From: Bricker, Robert
Sent: Tuesday, August 01, 2017 11:23 AM
To: 'Pam Walter'; Hill, Amanda; Powell, Markus P.; Hurman, Laura
Cc: Ron Thompson - Vanmar Associates, Inc. (ron@vanmar.com); Debbie VanSant (dkv@vanmar.com); Rob Scranton; Frank Potepan; Chip Bean
Subject: RE: Quartz Hill Lot 4 - REVISED Plot Plan - B17002436

From: Bricker, Robert [<mailto:RBricker@howardcountymd.gov>]
Sent: Friday, July 21, 2017 3:25 PM
To: Ron Thompson <ron@vanmar.com>
Subject: Quartz Hill III Lot 4 OSDS Plan

Subject: Project name QUARTZ HILL III
Project site address 14534 OLD FREDERICK ROAD 21723
Permit # B17002436 SDP # _____
Other information pertinent to this project _____

ON SITE SEWAGE DISPOSAL SYSTEM DESIGN PLAN
 LOT 4
 QUARTZ HILL III
 PLAT No. 22813-228125

Revision
For Health

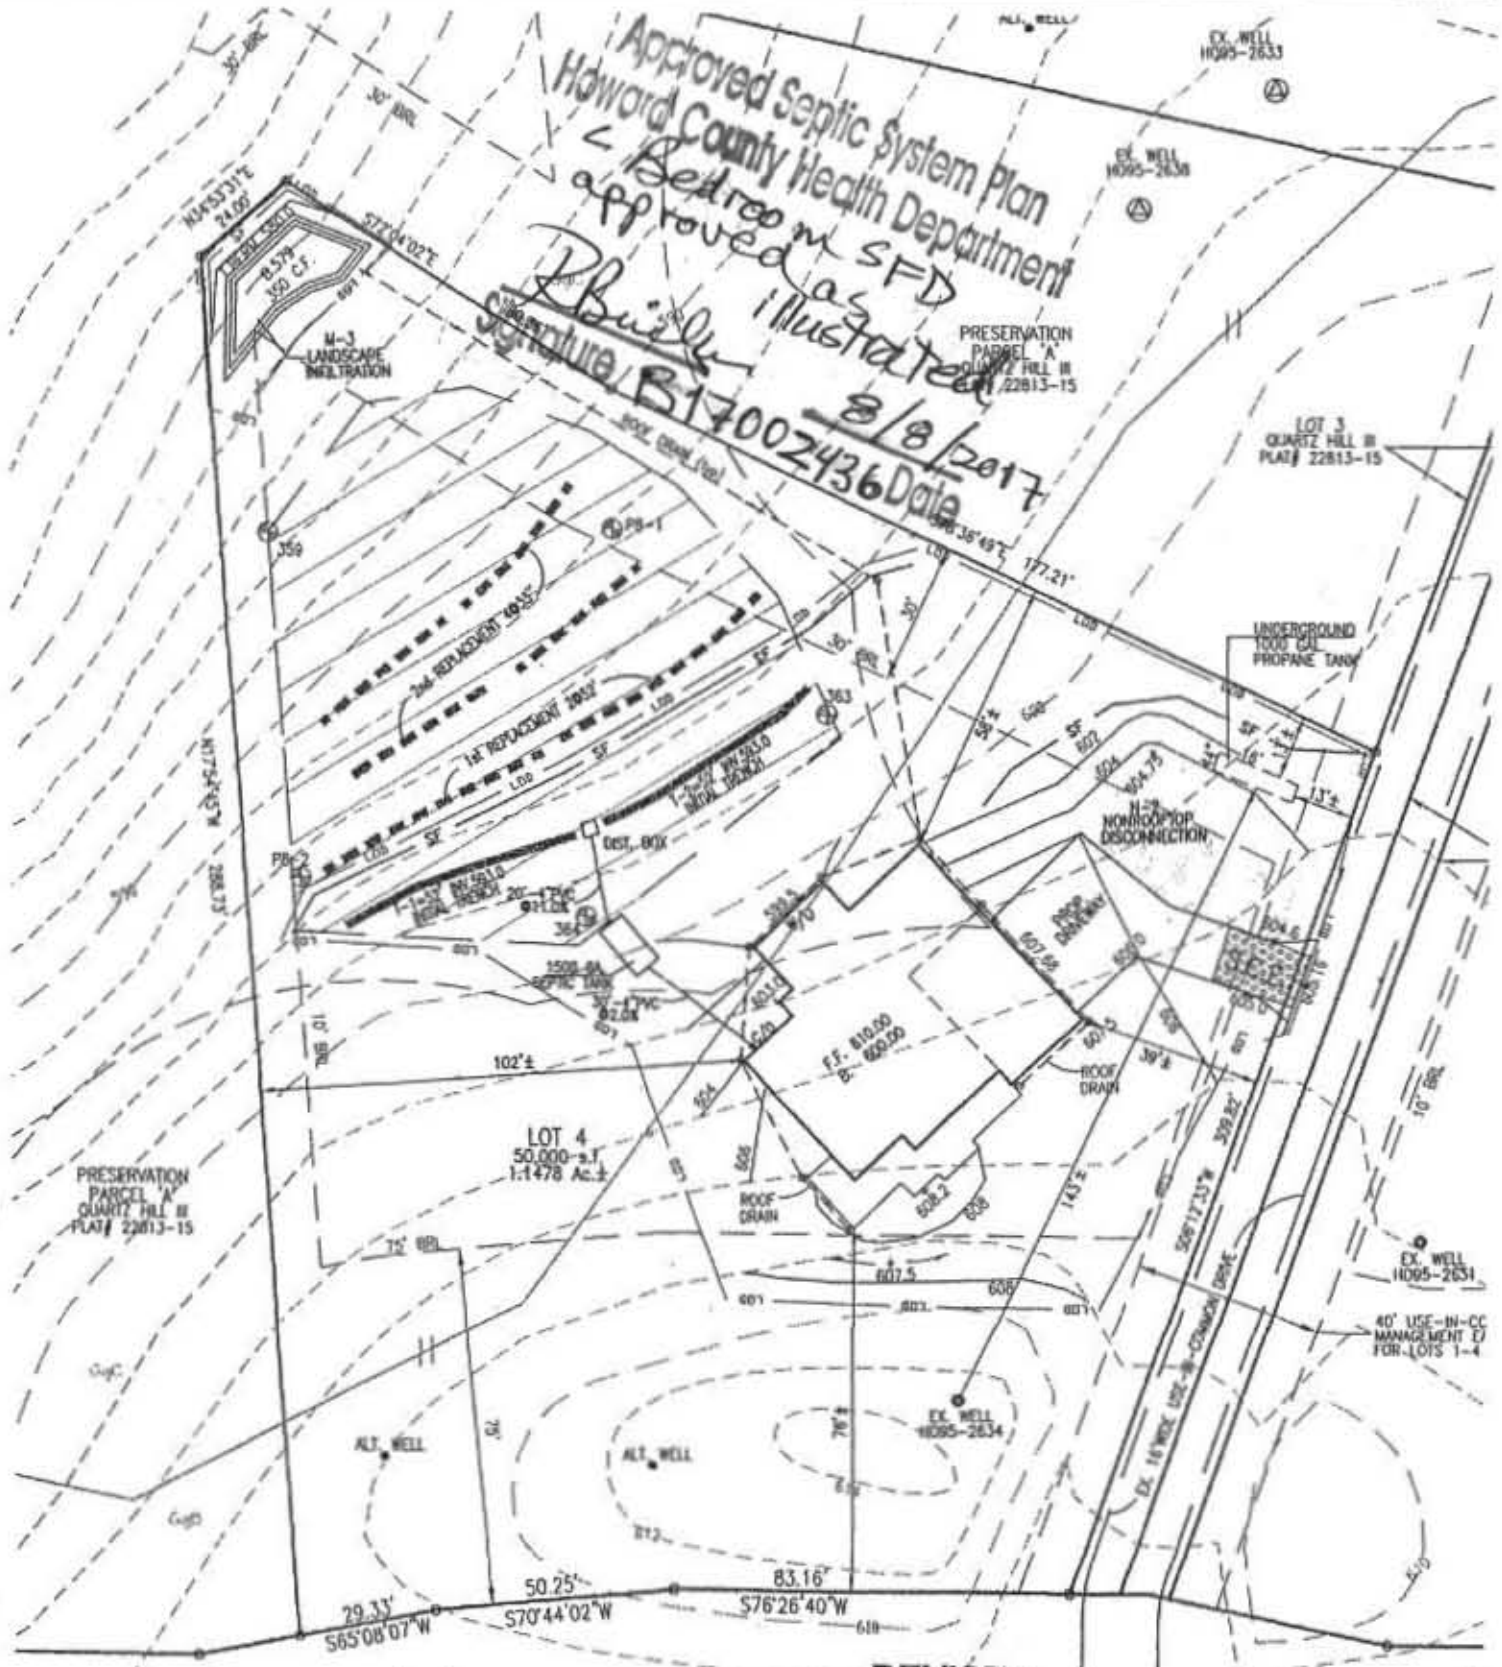
The revision looks 'OK'. Revisions of Plot Plans (like floor plan revisions) must be submitted with a formal Transmittal Sheet at Department of Inspections, Licenses, and Permits. In addition to 'Health', also submit copies for other reviewing agencies such as Building Review and Development Engineering, etc.

Attached is the revised, approved (by Health Dept) Plot Plan for Quartz Hill Lot 4. Can you upload this to your system for Health to sign off on?

Revised Per Health Dept.

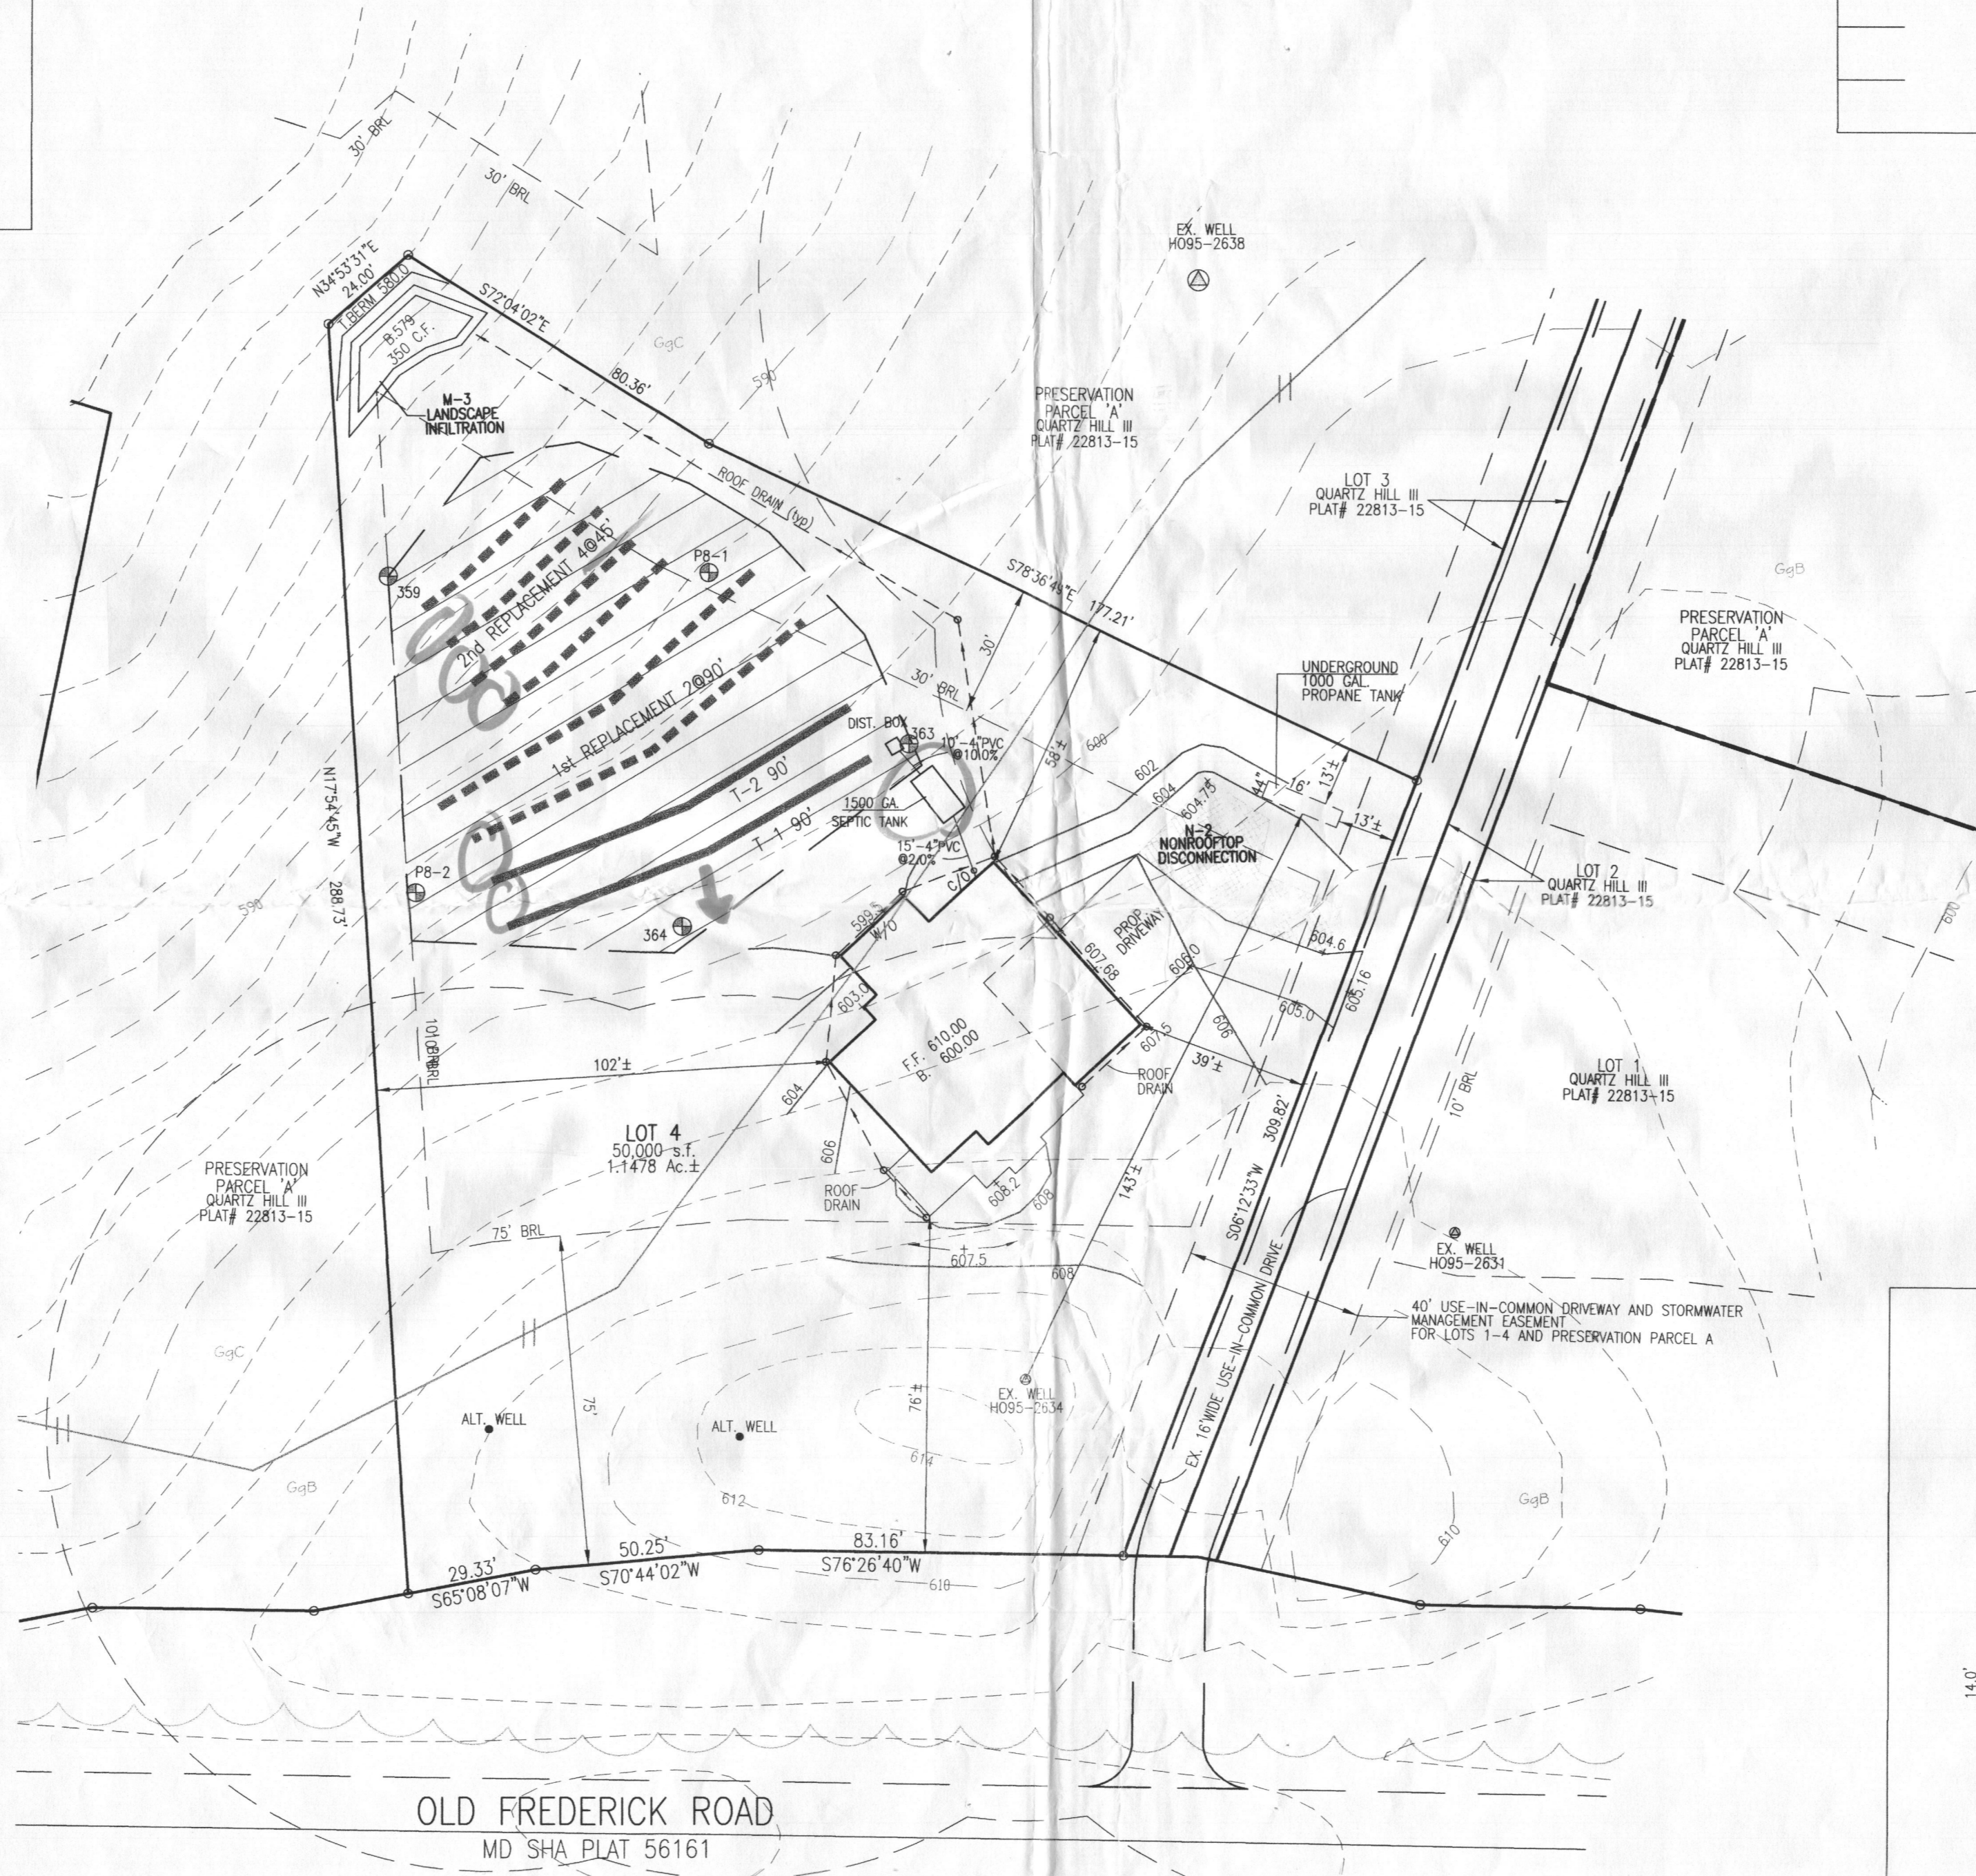
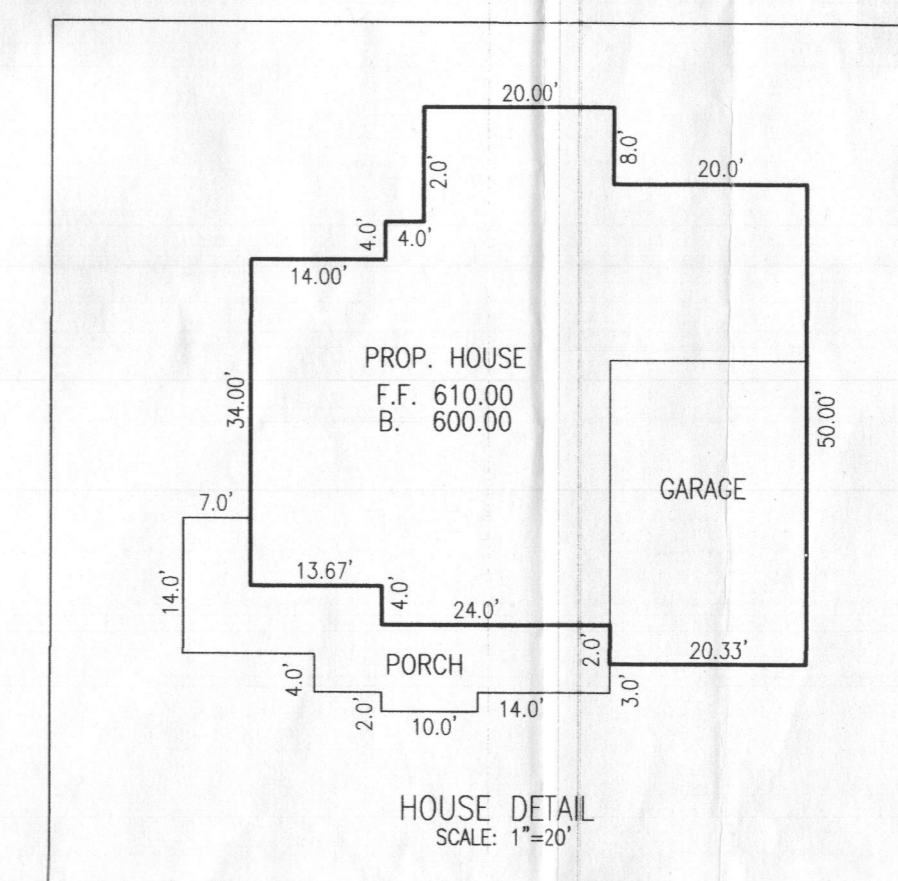
The plumbing inspectors at the County need to know where the sewer out is supposed to be.

Ron,
The septic tank location is good and the trench spacing is good. The trench lengths and trench placement for the Initial System and for the 1st Replacement System need to be tweaked.
You correctly calculate 104 feet for total length of trench for each of these two systems, but the total trench length you are illustrating is 114 feet for each. If you adjust the trench lengths and shift them to a little higher elevation in the SDA, the OSDS Plan will be ready for approval.

Ron,
That isn't the issue. The 3-ft wide trench does make for better use of the SDA. Placing the trenches across the width of the SDA (rather than stacked) is a better design for discharge. On this property it also allows placement of the tank a little further from the house, thereby opening more space for the owner's deck, patio, etc.
I forgot this item:
As the septic tank and sewer line have moved the Plot Plan must be revised. Submit a formal revision sheet to DILP with copies of the Plot Plan for the Health Department and for the other agencies to review.
Robert Bricker, REHS/RS, L.E.H.S.

Ron,
You did address the issues I identified in my comments. When reviewing I noticed that you labeled the trench lengths incorrectly for the Initial System and for the 1st Replacement System, 57 ft rather than 52 ft.

I also noticed that the trenches for both the Initial System and for the 1st Replacement System can be laid out across the width of the SDA with a Distribution Box in the center. This design utilizes about the same area for the Initial System, and it allows for the tank to be installed at least partly within the SDA.
Please redesign accordingly, edit the Profile, and re-submit the OSDS Plan for approval.

Thank you. Regarding the Plot Plan, I do not think we need to resubmit since the lot grading, sediment control and LOD do not change. The only change is location of septic tank which would be cover by the OSDS Plan.

Please the attached plan with the changes you requested. If acceptable, I will submit the paper copies.
